**Addendum No.1 – Bella Coola Airport Fuel System Upgrade**

**Date: January 12, 2022**

**Addendum 1 - Figure No. 1 – Cable Route Site Plan Attached on the Following Page**

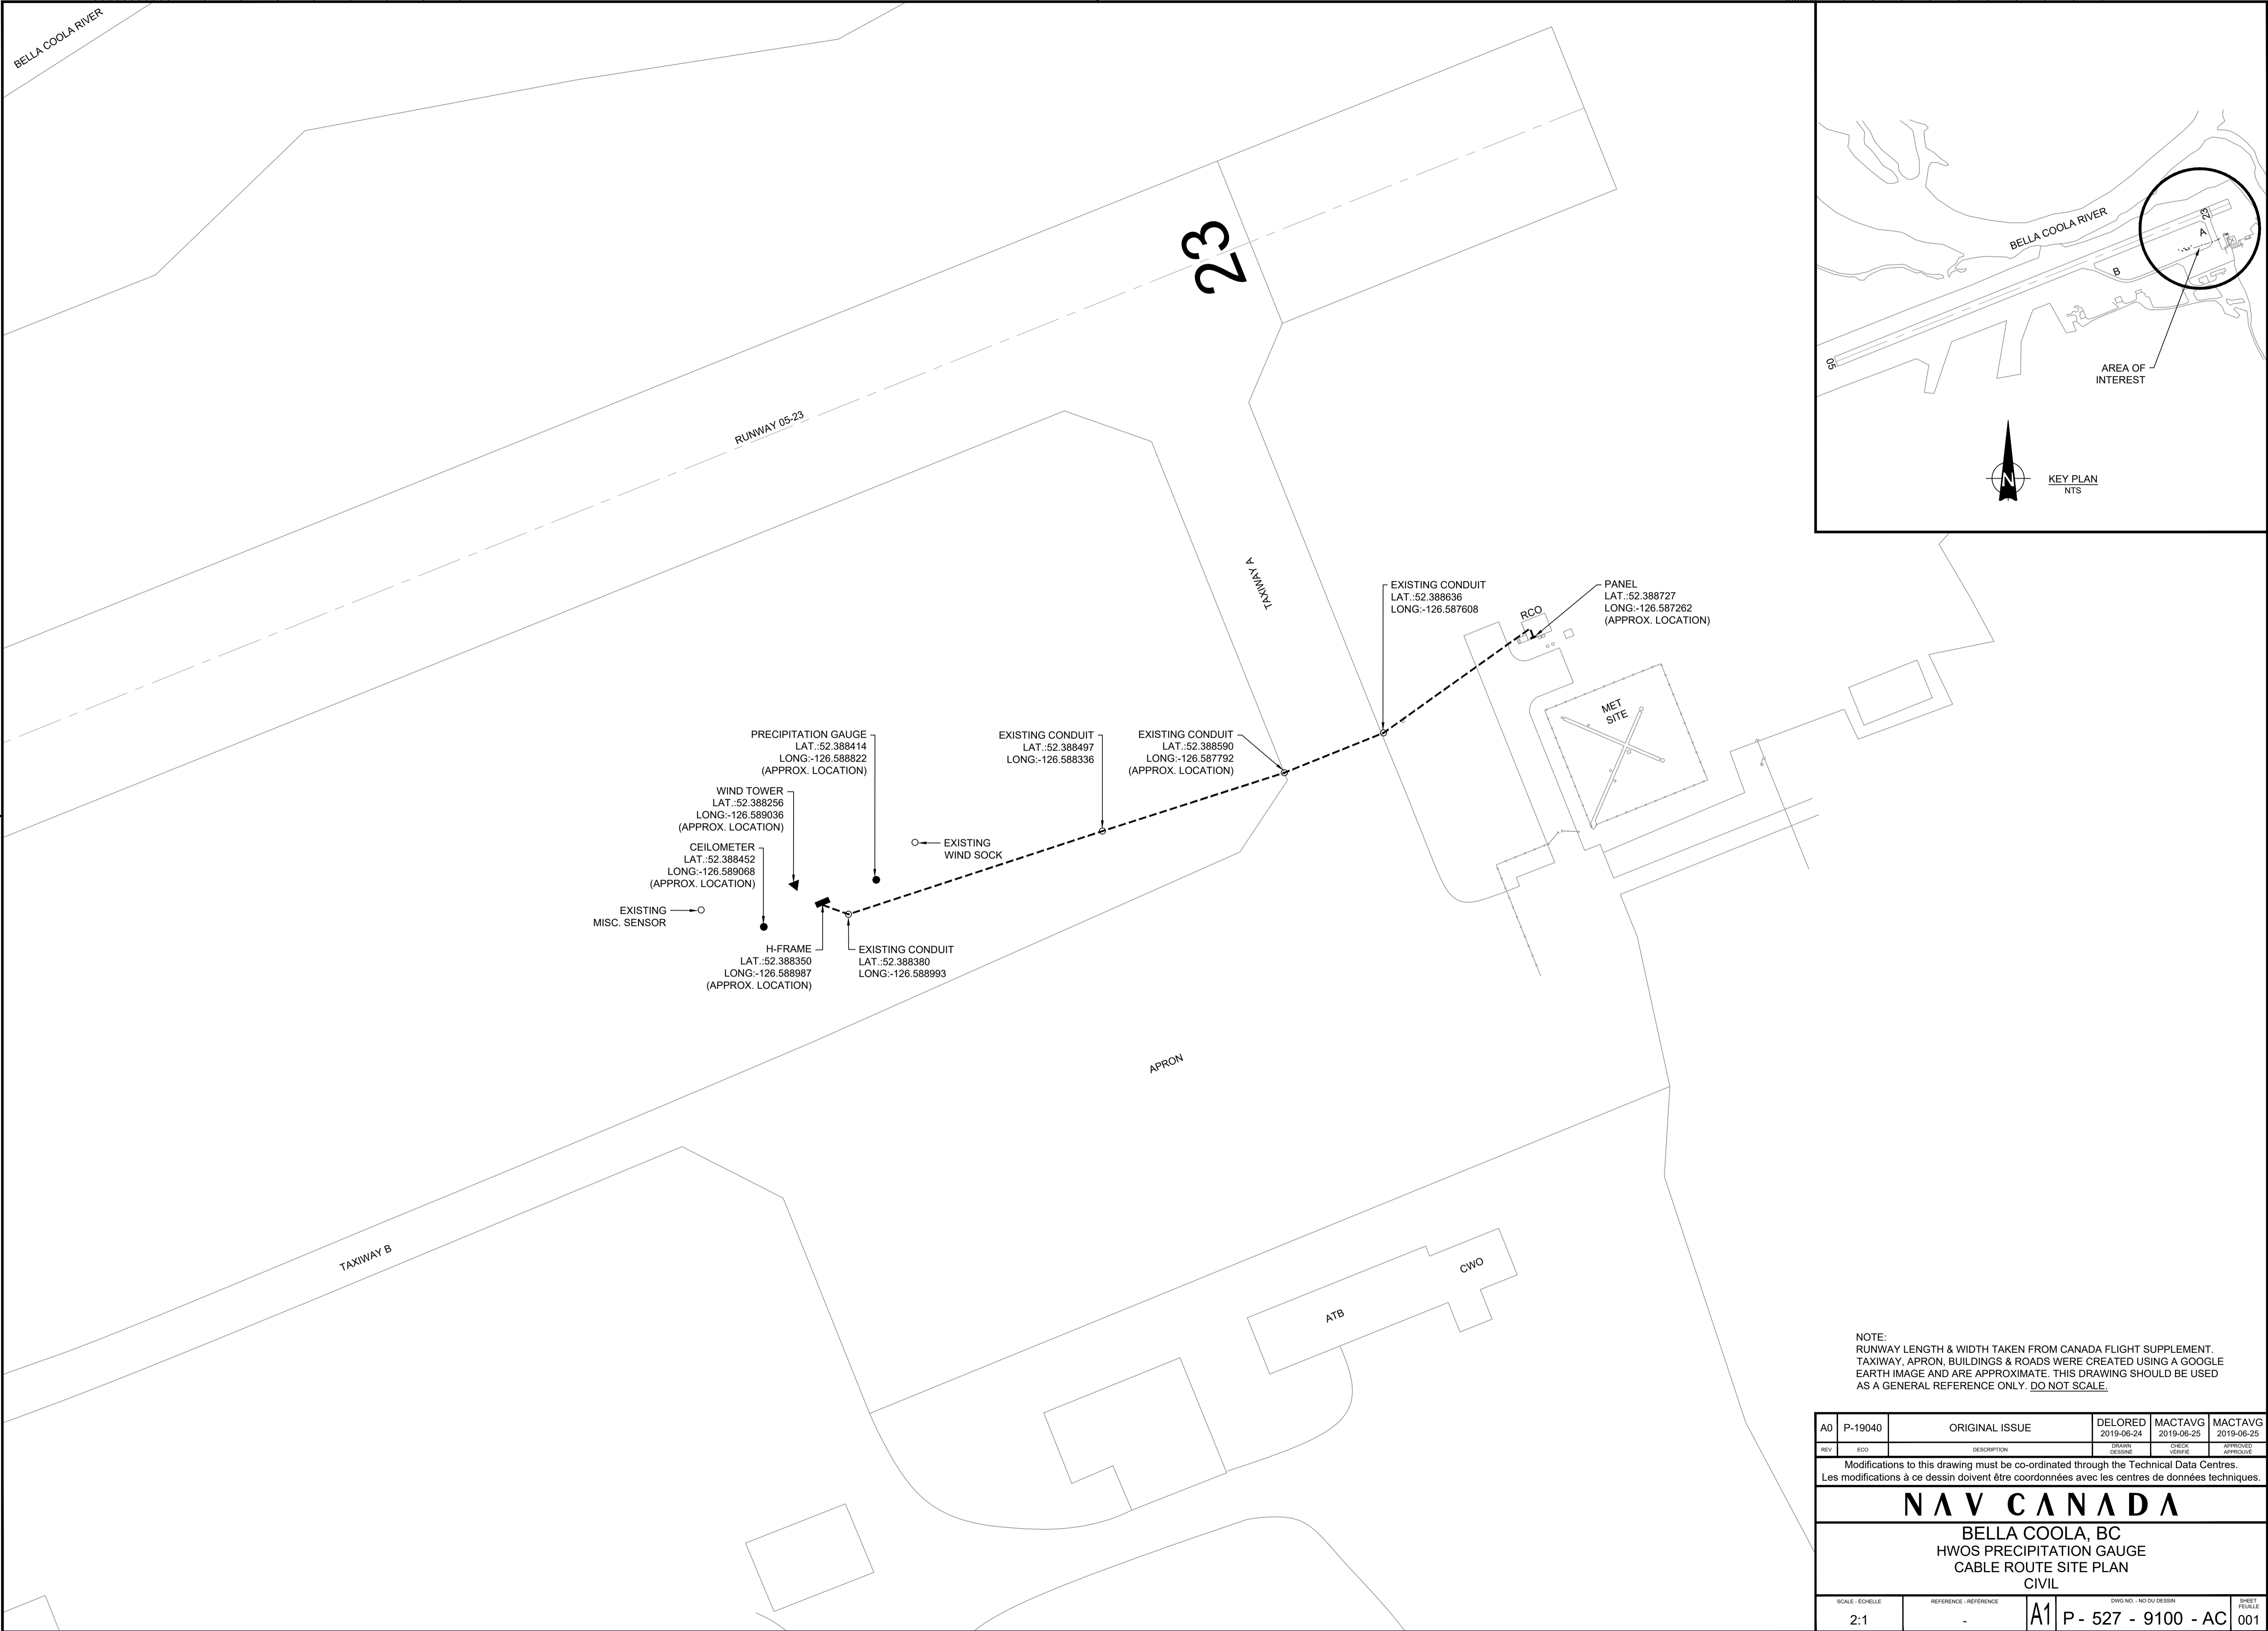
<b><u>23</u></b>	Please advise the status of your Bill C69 application/submission.	It is the responsibility of the successful contractor to prepare and submit all necessary federal and provincial applications in support of the project.
<b><u>24</u></b>	Please confirm Airside Insurance Requirements.	Insurance requirements are identified in Section 5.6 of the RFP document.
<b><u>25</u></b>	Please confirm Bonding Requirements for the successful proponent.	There are no Bonding requirements as part of this project.
<b><u>26</u></b>	Please confirm the existing capacity and capability of the Oil Water Separator (OWS).	The CCRD is unaware of the existing capacity or capability of the Oil Water Separator (OWS). Proponents are encouraged to visit the site to inspect the facility.
<b><u>27</u></b>	Please provide U/G Service Drawings and in particular the U/G oily water drainage system	Known U/G services are shown on the attached drawing (Addendum No. 1 – Cable Route Site Plan).
